## RE PRELIMINARY SERVICING ADVICE PROPOSED SUBDIVISON OF LAND; 98 COACHWOOD DRIVE, MEDOWIE

Thank you for your request for Hunter Water's preliminary advice for the provision of water and sewer services to your proposed development: subdivision of 1 lot into 200 lots at Lot 1 DP 1019113, 98 Coachwood Drive Medowie.

Figure 1: Water Supply Connection Point(s)

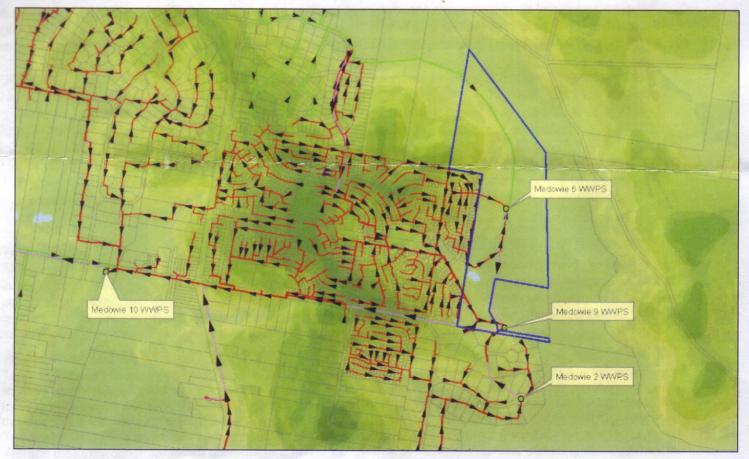
There is currently sufficient capacity within the water supply system to service the development, however, minor lead-in works would be required to connect to the local network. The location of potential water connection points is provided in Figure 1. Depending on the rate of development growth within Medowie some additional network augmentations may be required to service the full development of the site. Additional requirements would be assessed in detail at the section 50 application stage.
